V2500-A5 PROPULSION SYSTEMS NON-MODIFICATION SERVICE BULLETIN

This document transmits the Revision 4 of Non-Modification Service Bulletin V2500-ENG-73-0228.

NON-MODIFICATION SERVICE BULLETIN – ENGINE – VARIABLE STATOR VANE (VSV) ACTUATOR –
LOW PRESSURE (LP) RETURN LINE RE-ROUTE PIPEWORK – FUEL TUBE REPLACEMENT AND HARNESS
INSPECTION

Figure 1 (Sheet 1 of 5)

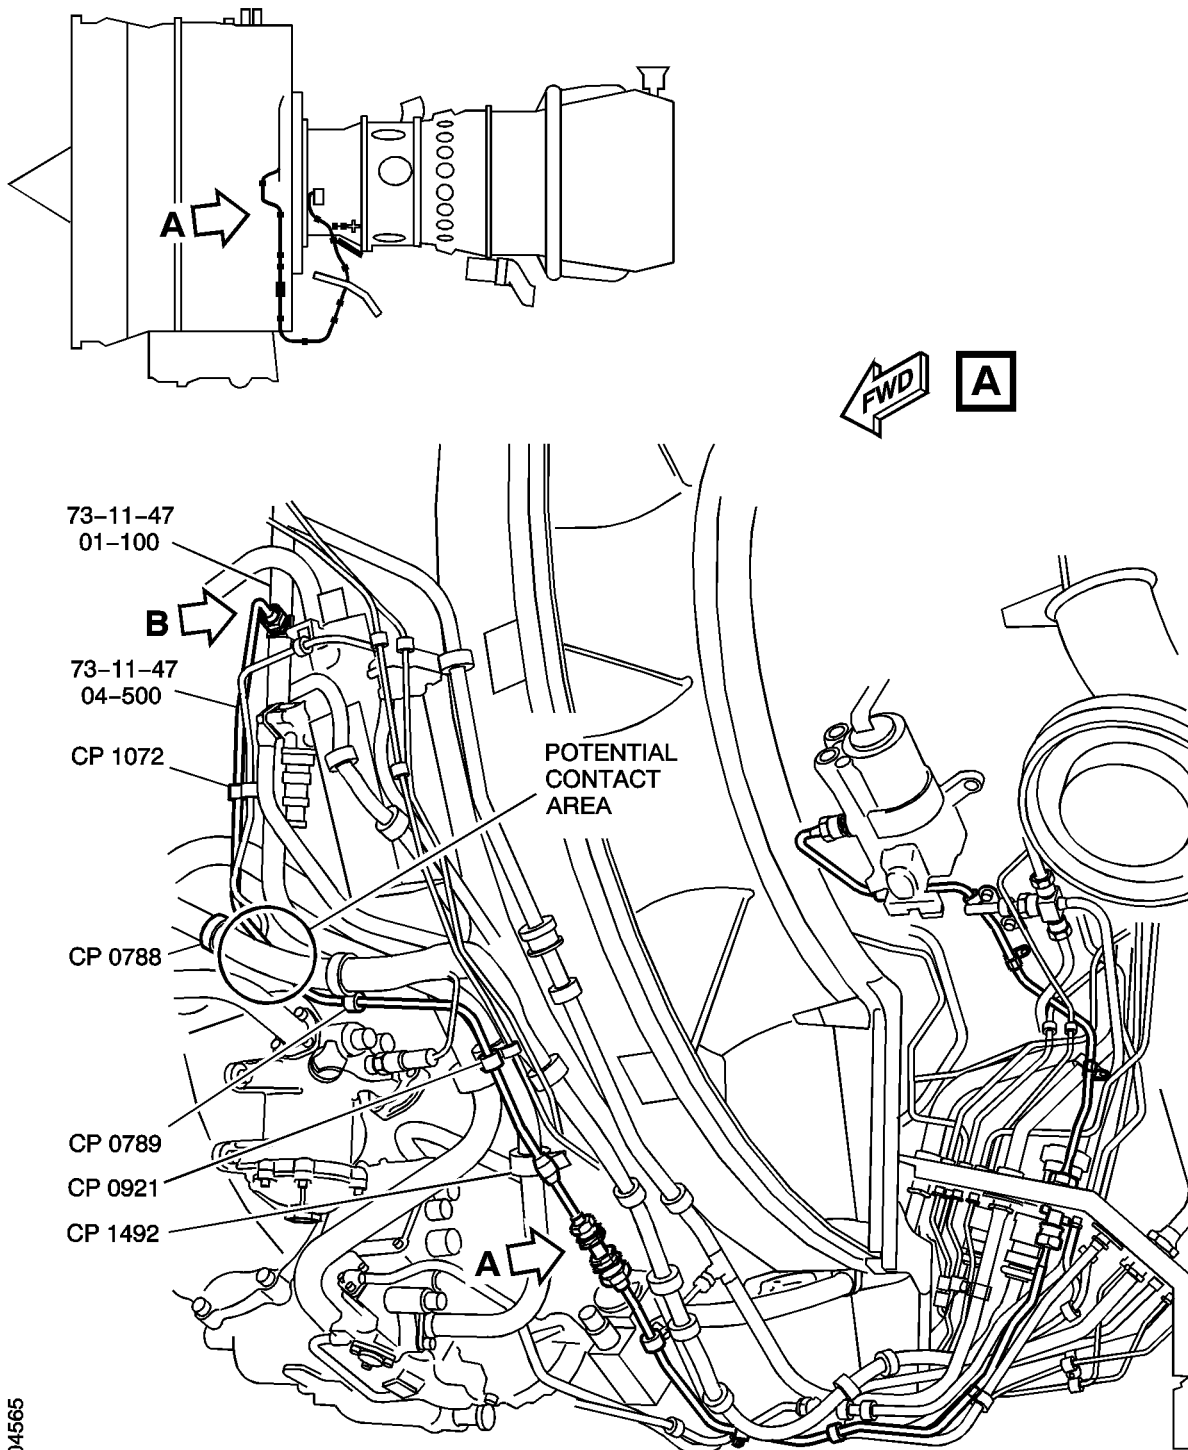
(a) Remove the tube assembly (73-11-47, 04-500) from the engine (Refer to Figure 1)

- (4) Install a new tube assembly (73-11-47, 04-500) (Refer to Figure 1)

- (f) Make sure the tube (73-11-47, 04-500) is positioned correctly and torque the tube nuts to 230-248 lbf in. (26-28 Nm).
 - (g) Safety the tube nuts on tube (73-11-47, 04-500) with CoMat 02-126 Lockwire.

- (h) Torque the three nuts (73-11-49, 26-796), (73-11-49, 26-164) and (71-51-41, 01-877) of the clip positions CP1492, CP0921 and CP0789 to 36-45 lbf in. (4-5 Nm).

- (i) Torque the bolt (73-11-49, 26-173) of the clip position CP1072 to 36-45 lbf in. (4-5 Nm).
 - (j) Retighten and torque all adjacent hardware that have been loosened before, to ensure stress-free installation of tube (73-11-47, 04-500).
